**Town of Kittery
Planning Board Meeting
March 9, 2023**

ITEM 2 – 39 Badgers Island, Sketch Plan Review – Minor Cluster Subdivision

**KITTERY PLANNING BOARD
FINDINGS OF FACT -
for
39 Badgers Island West
Minor Cluster Subdivision Plan**

CONDOMINIUM SITE PLAN
39 BADGERS ISLAND WEST
CONDOMINIUM

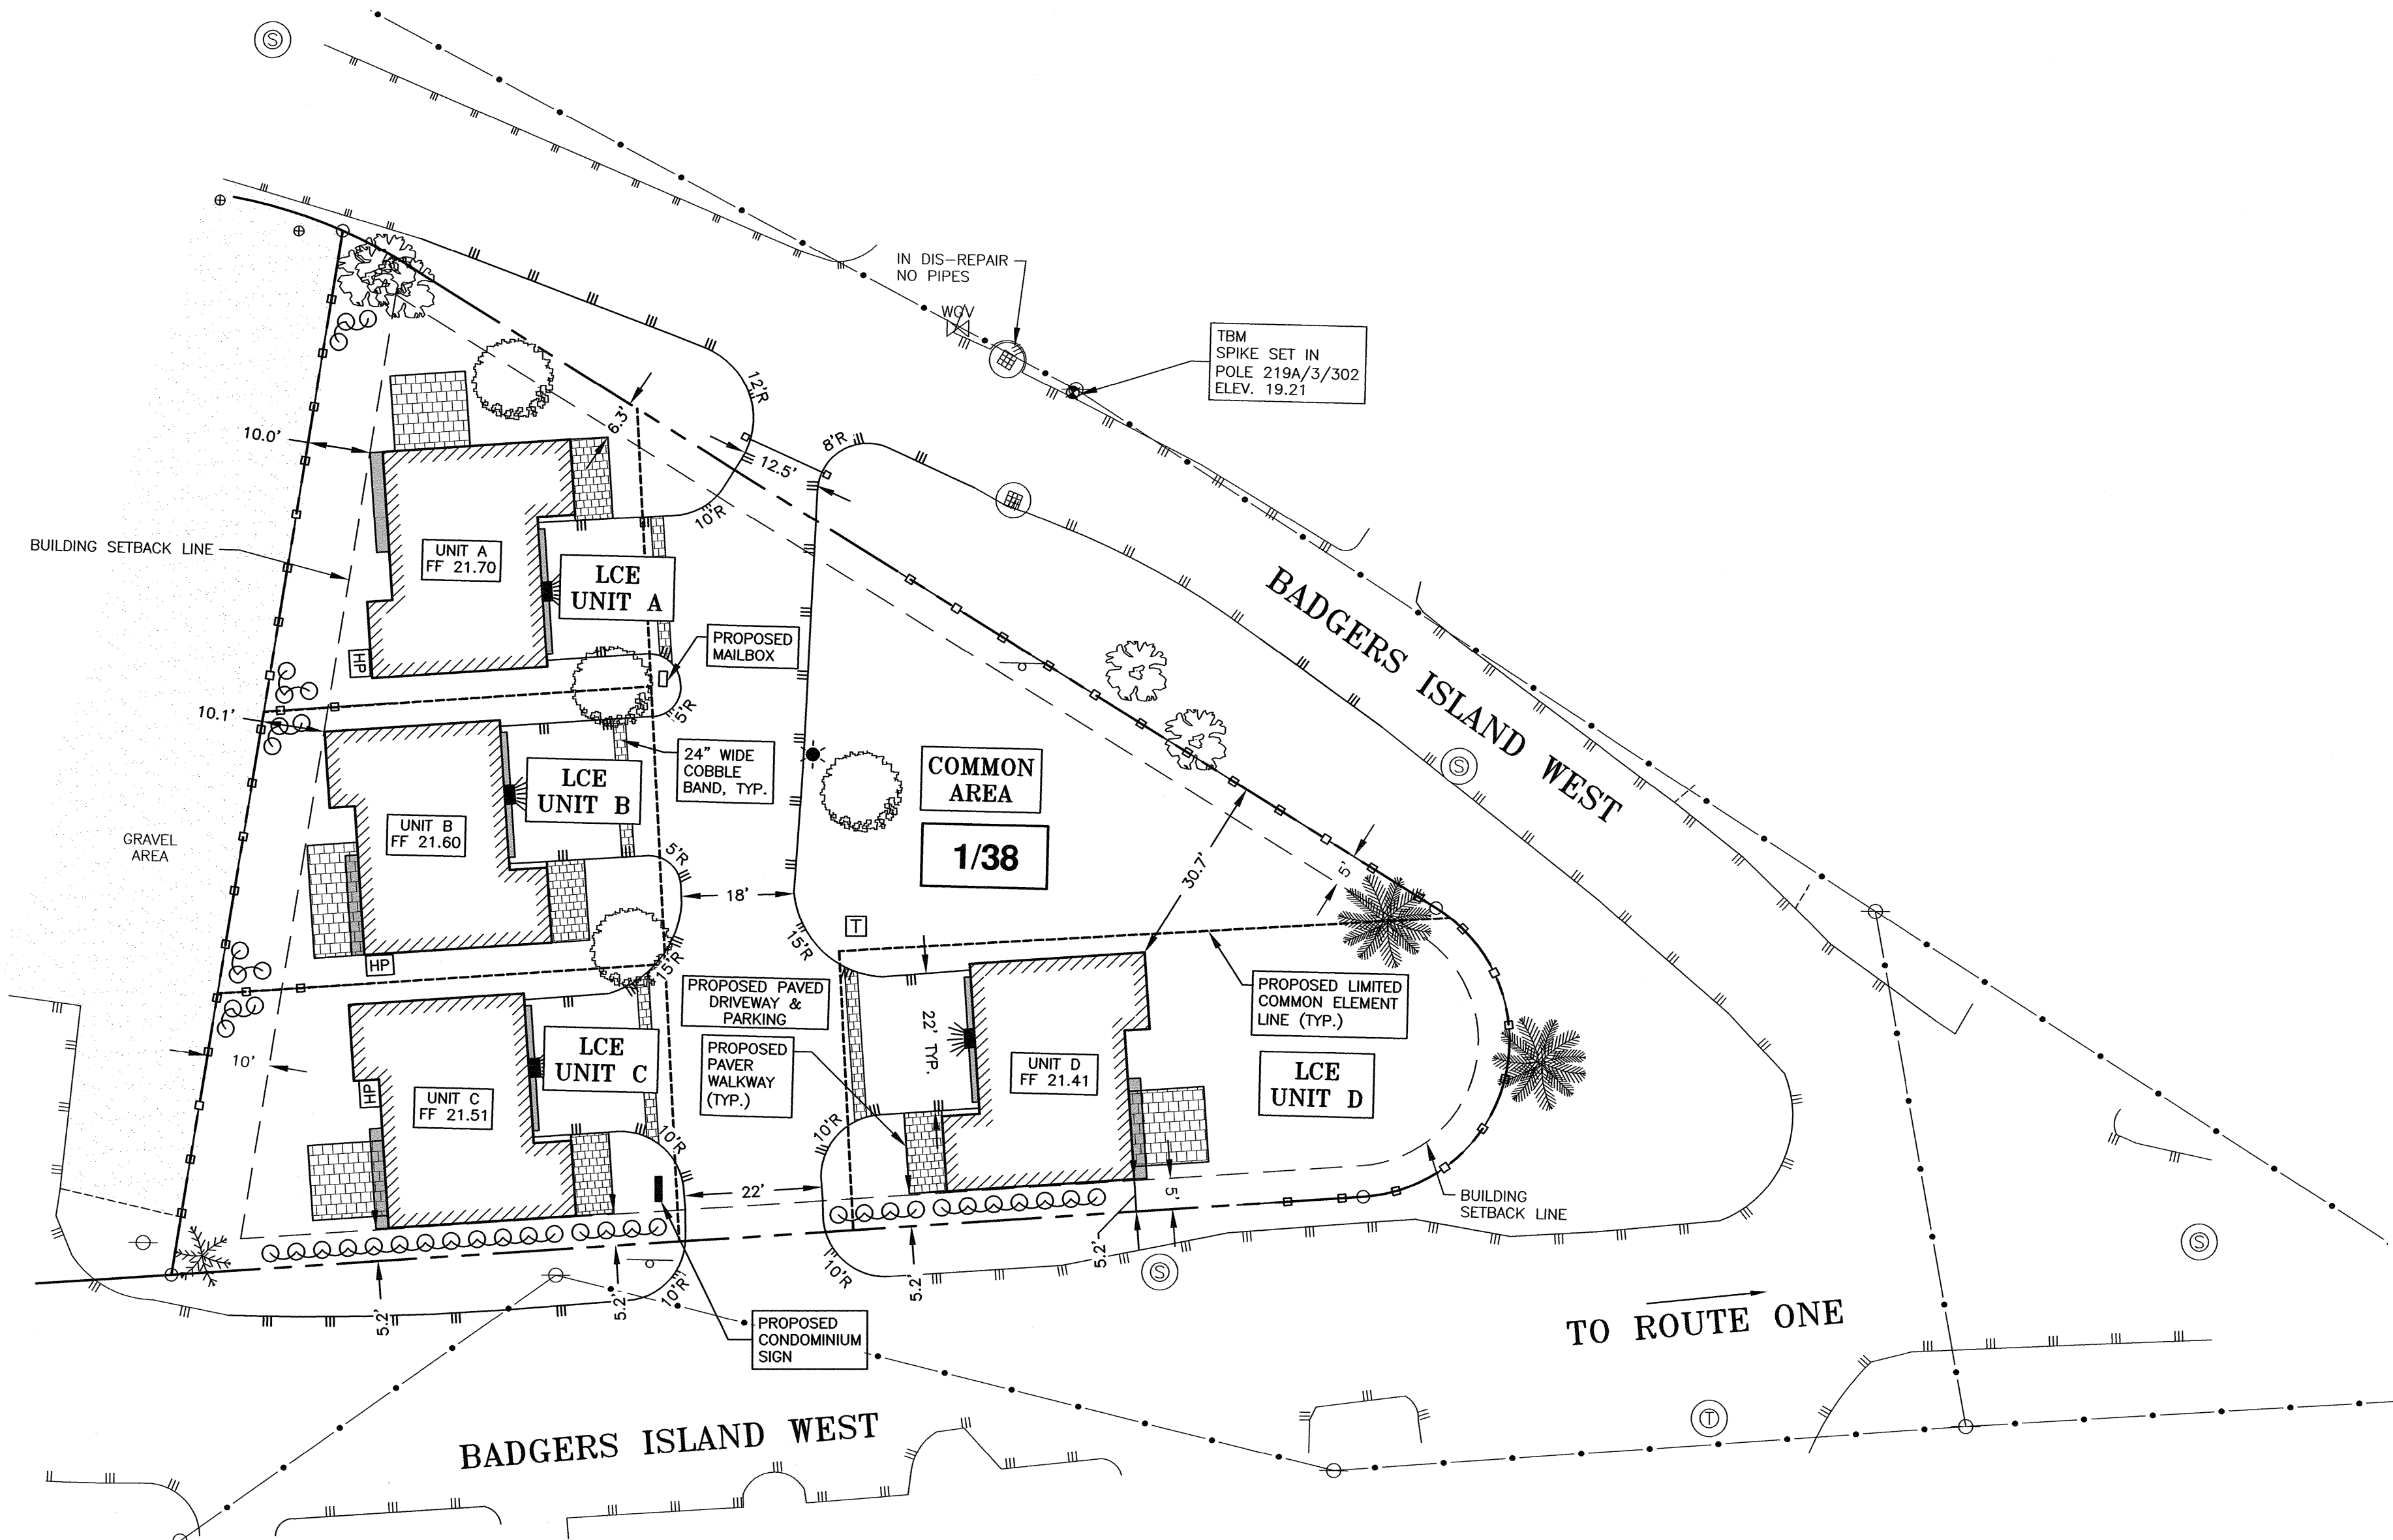
- Cover Sheet – This plan shows the design team, site location, and Legend. **Revised Date.**
- Condominium Site Plan - The plan is the plan that will be recorded for the creation of the Condominium at the site. The plan shows Common and Limited Common areas. **Revised sign location.**

EXISTING CONDITIONS PLAN

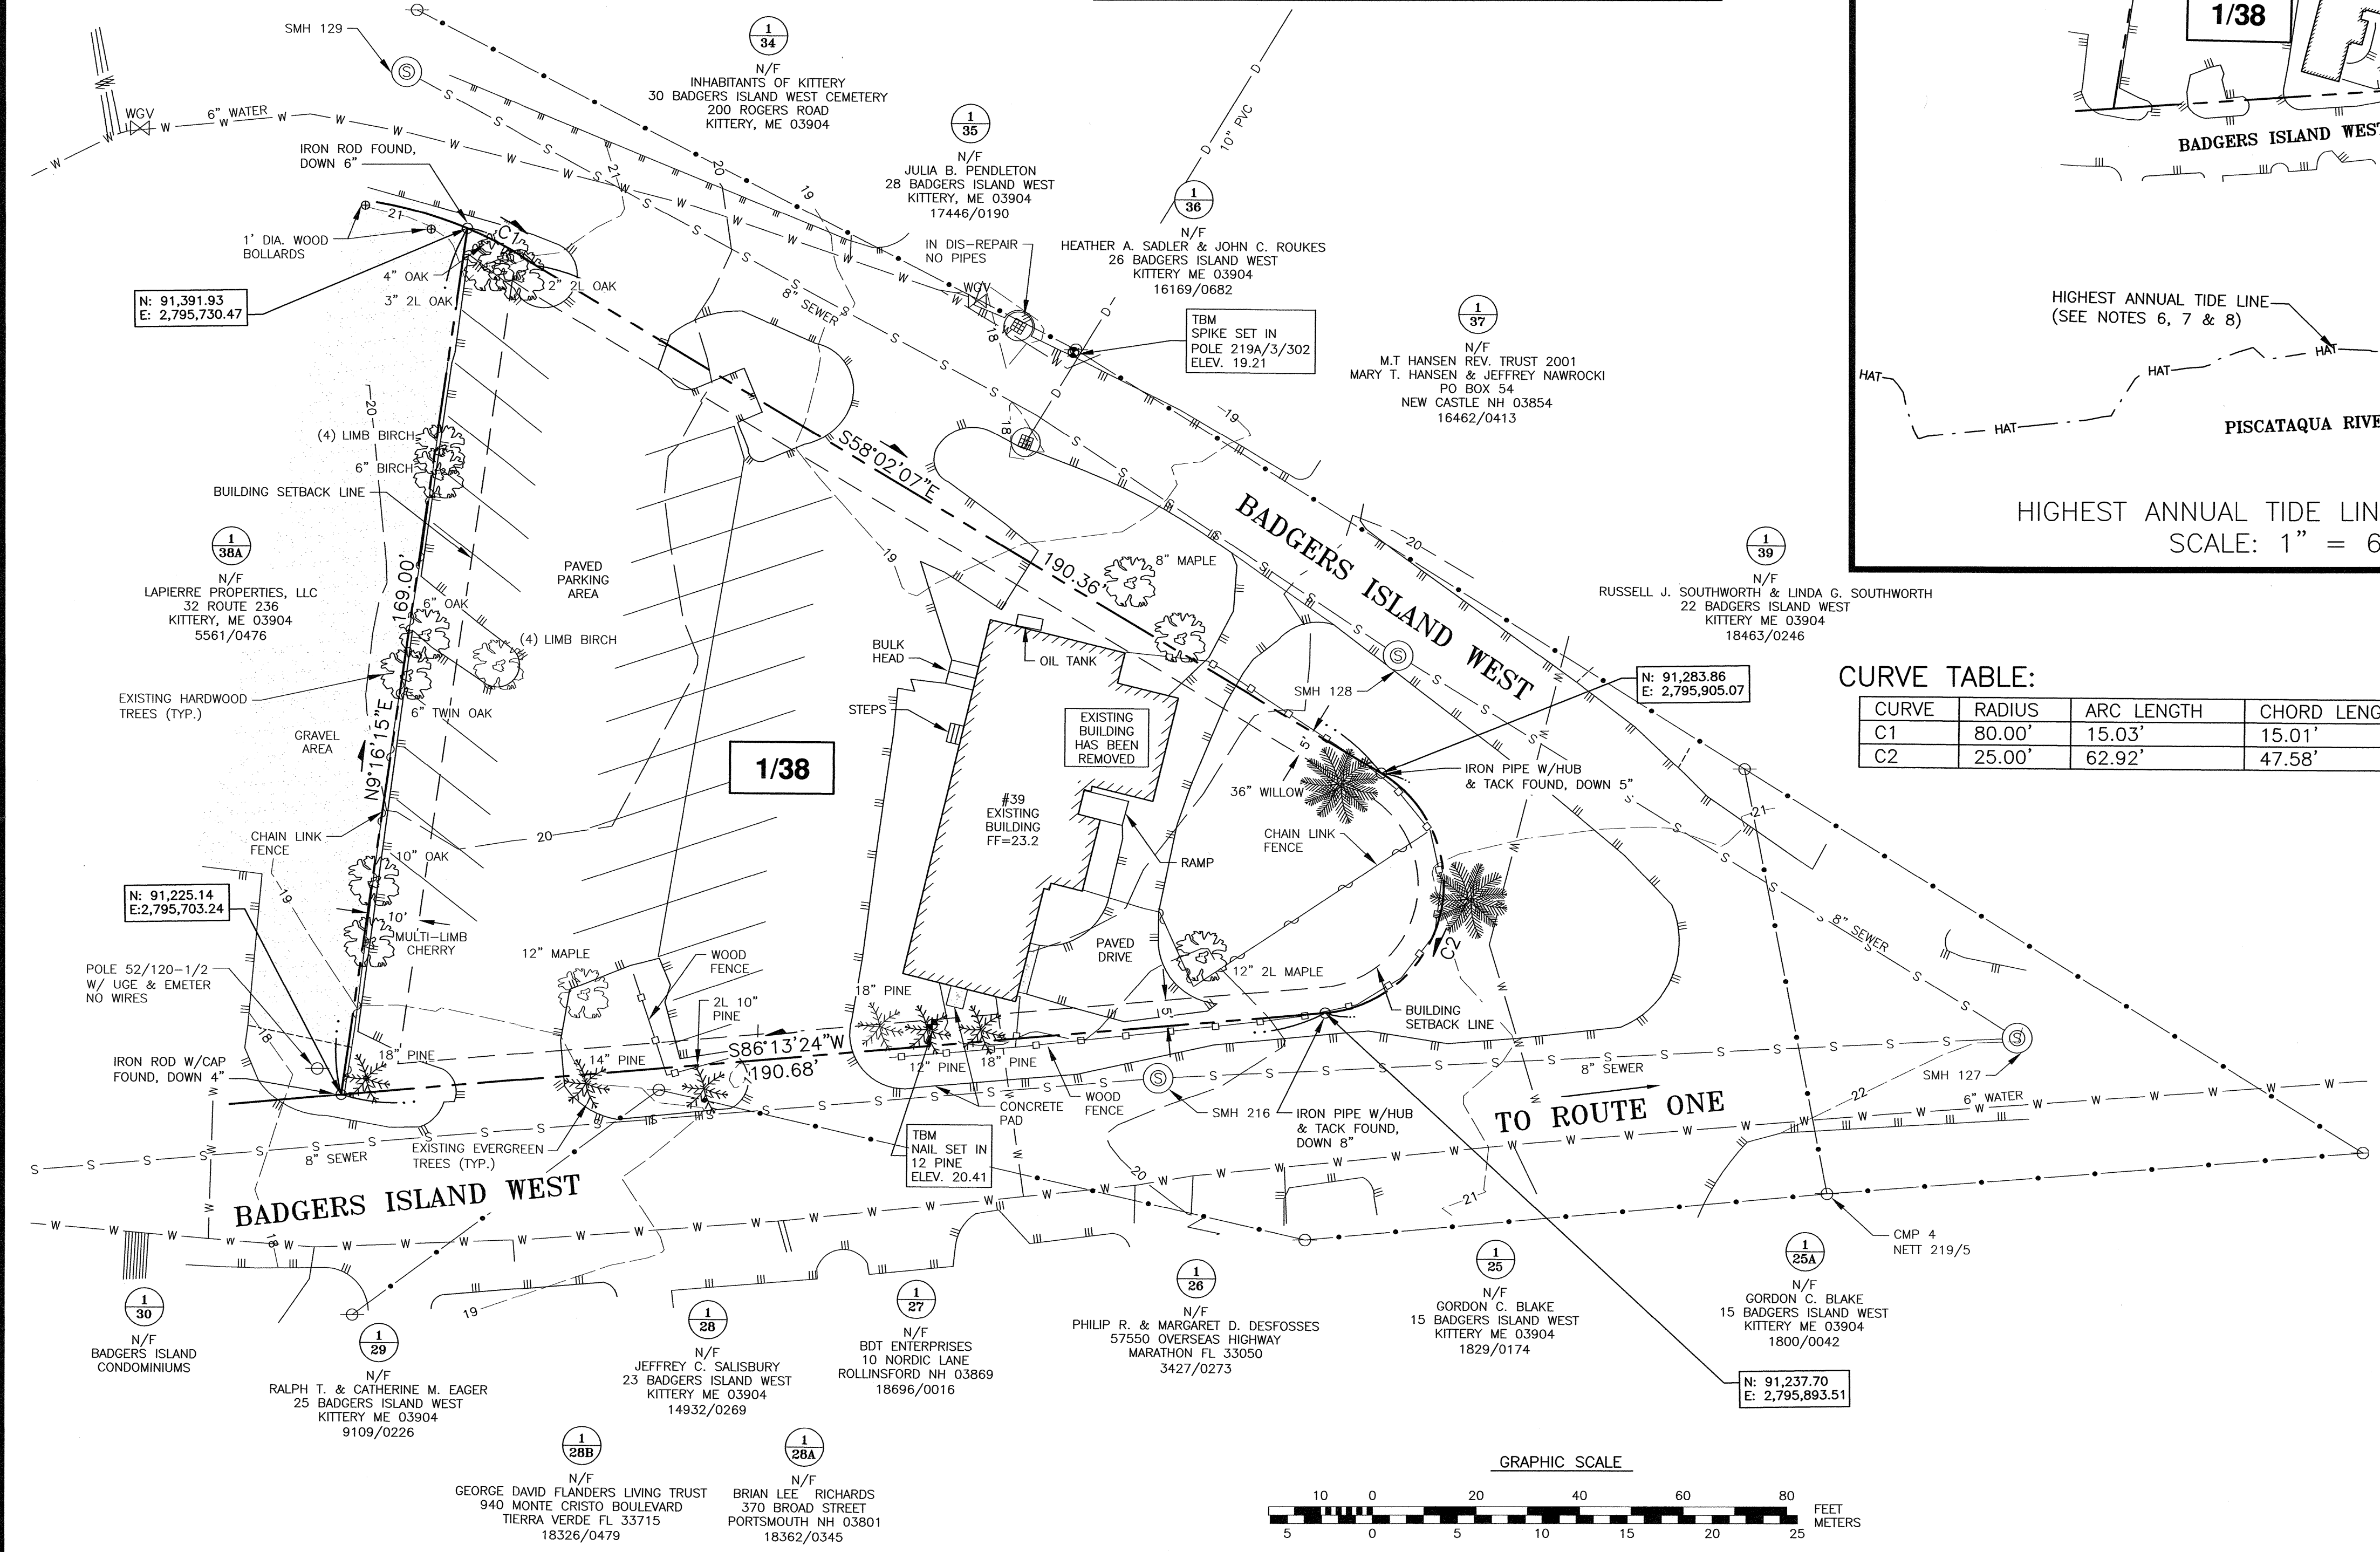
- Existing Conditions Plan C1 – This plan shows the current improvements on the property (including the recently demolished building) and the site boundary lines. **Add SPC (Coordinates).**

UTILITY
PLAN

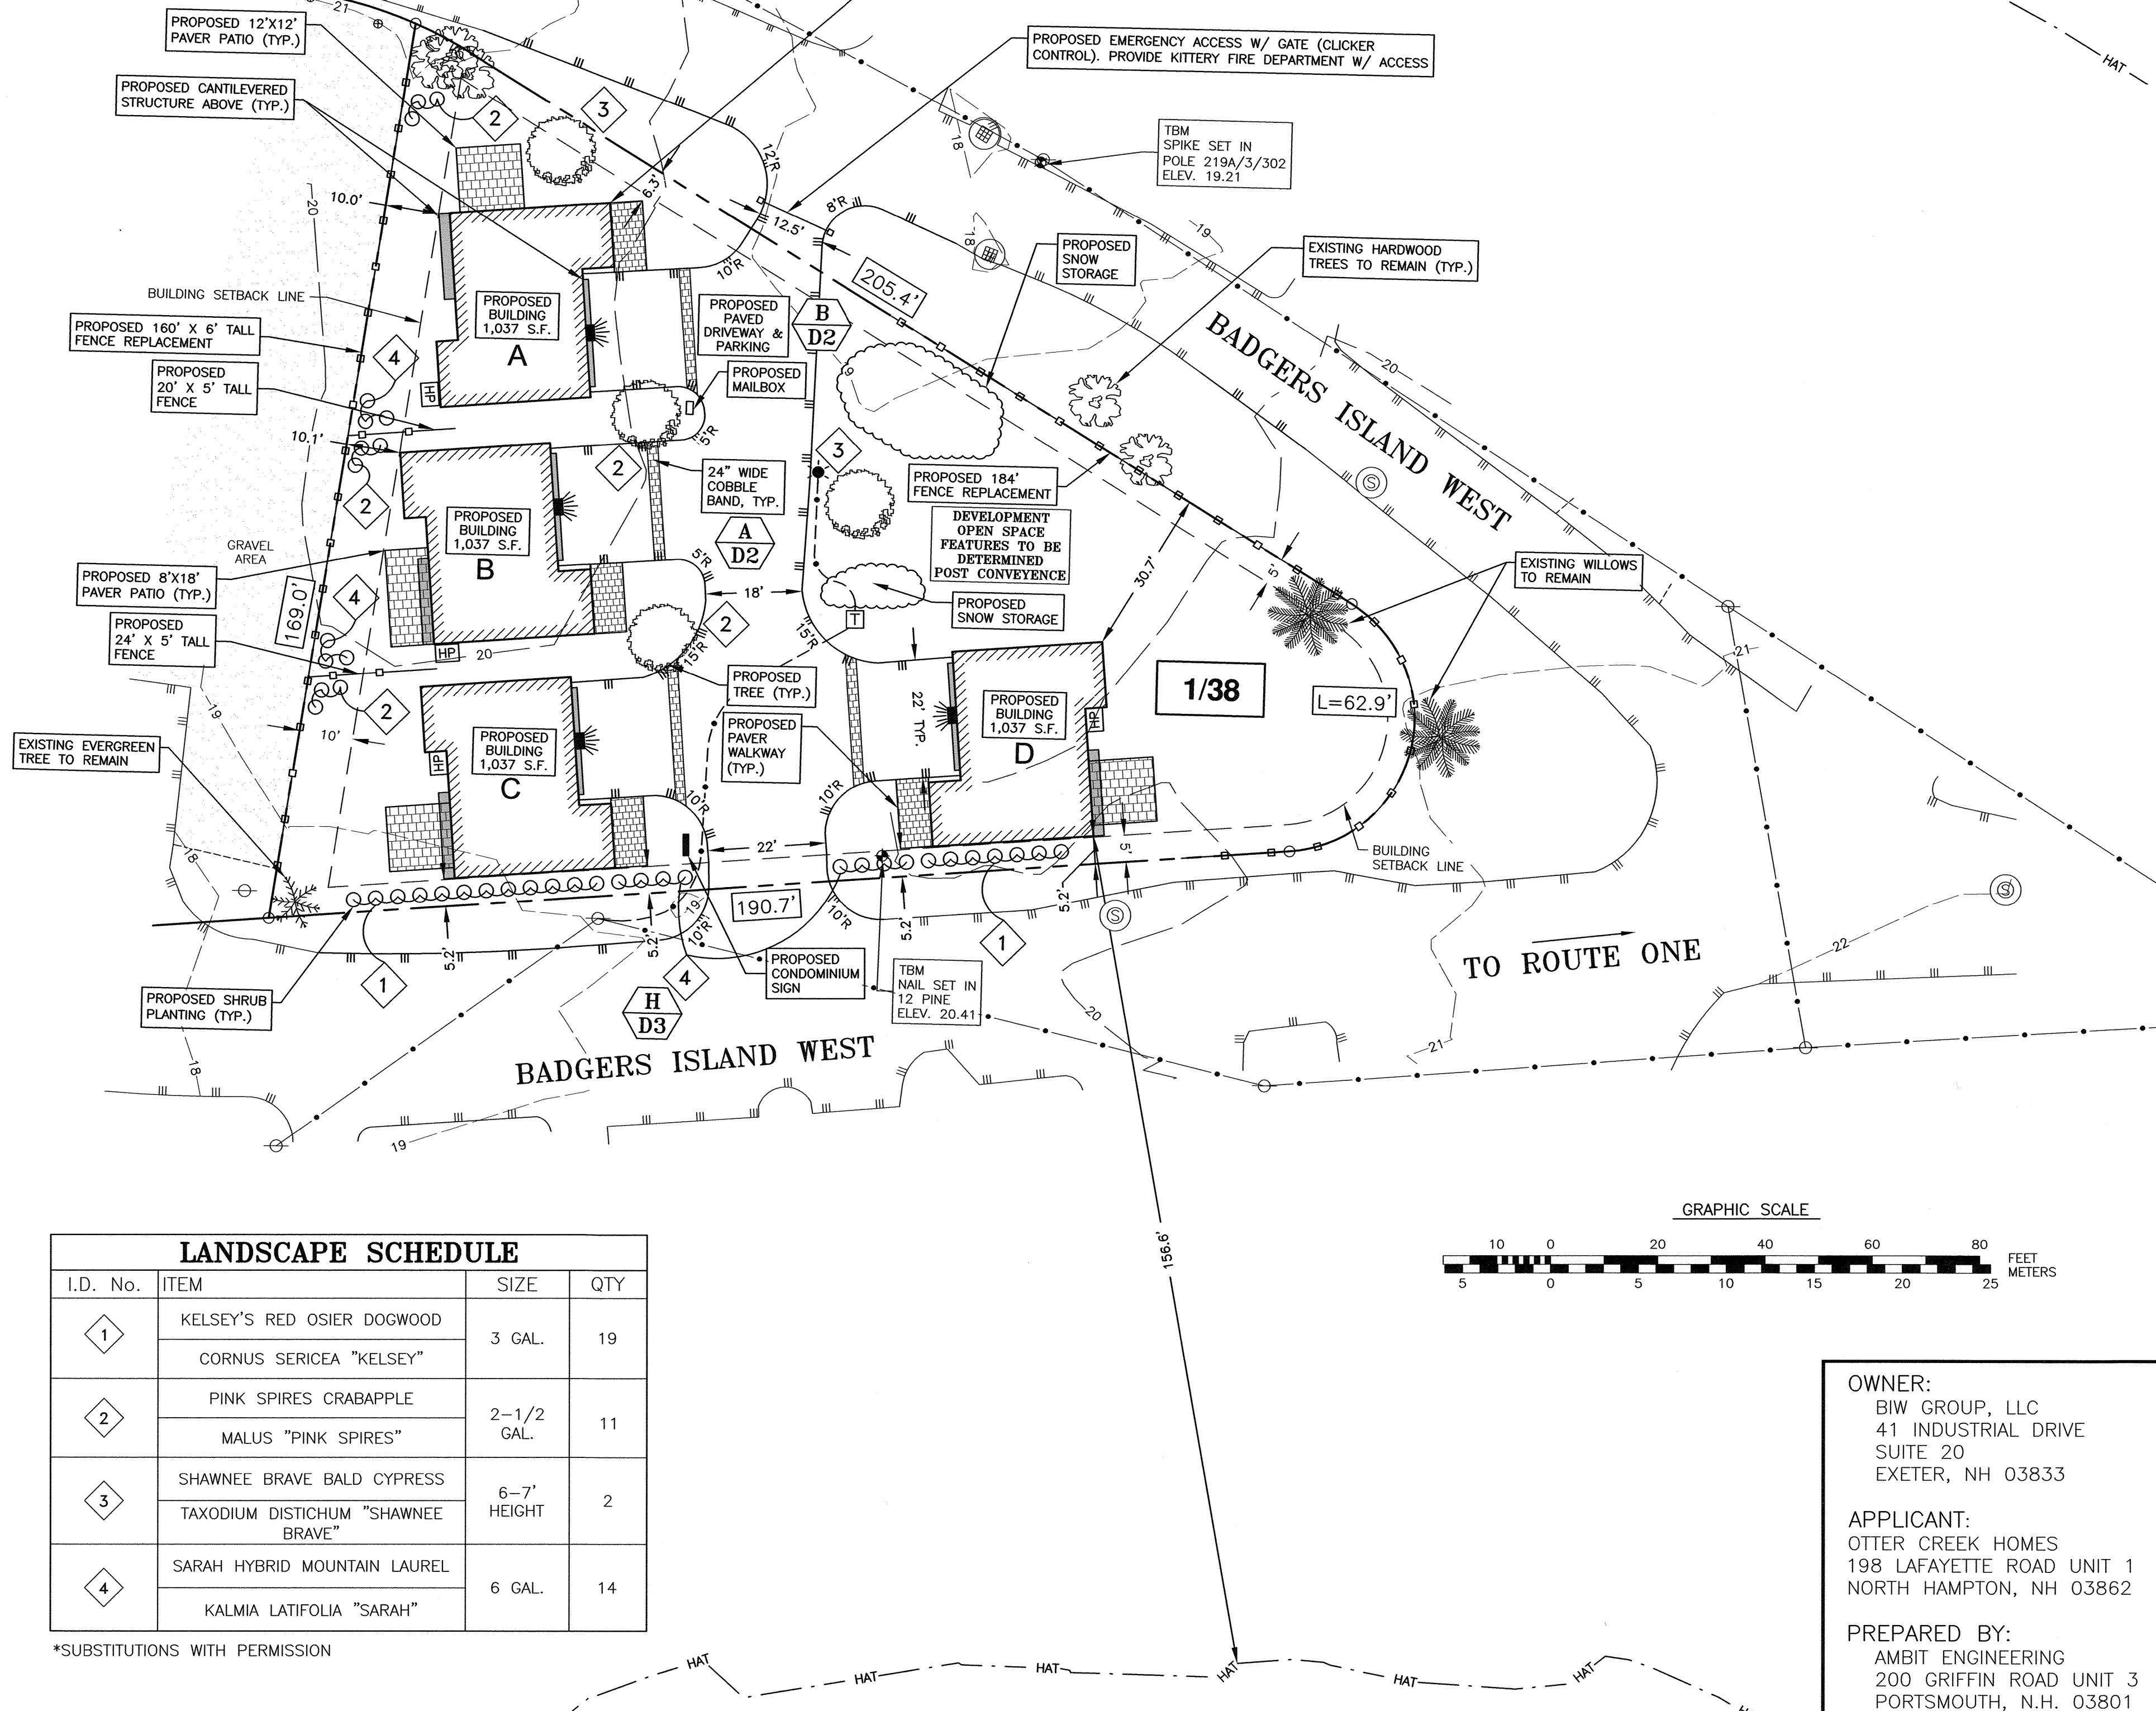
- Utility Plan C3 – This plan shows the utilities required to service the proposed buildings. The plan has tables with the proposed elevations. **Revised sign location.**
